Docket Item # 3
BAR CASE # 2008-0148

BAR Meeting
September 24, 2008

ISSUE: Demolition/Encapsulation
APPLICANT: James and DeShuna Spencer
LOCATION: 229 North West Street
ZONE: RB/Residential

Figure 3 Proposed East Elevation

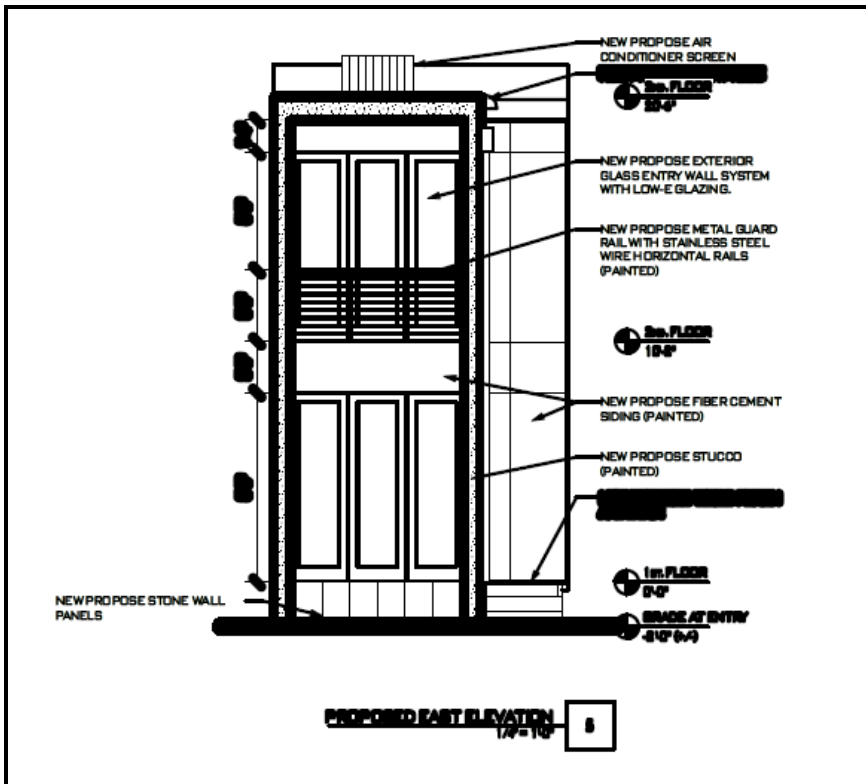
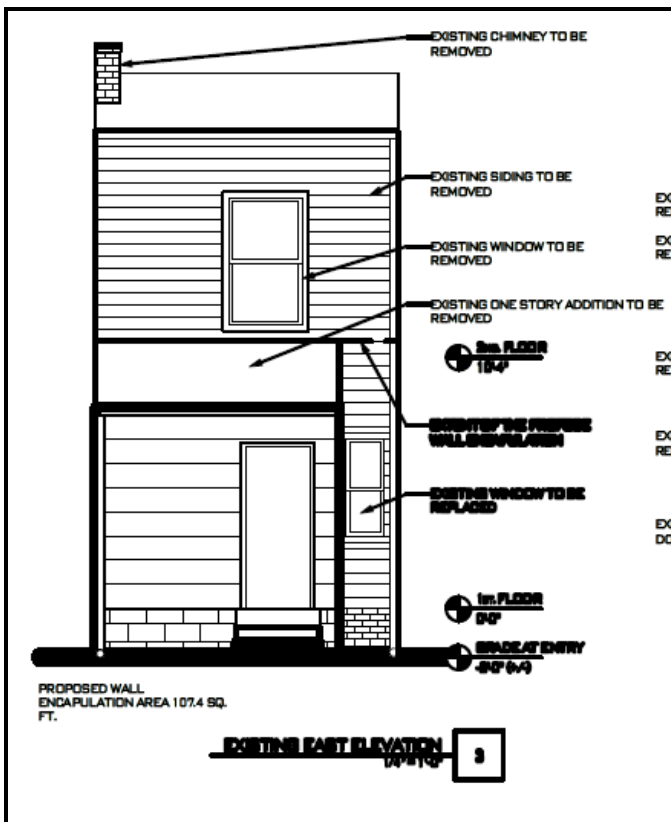
S-1 Double-hung paired windows at first and second floor front façade be replaced by single, double-hung, two-over-two wood windows to reflect original fenestration scheme.
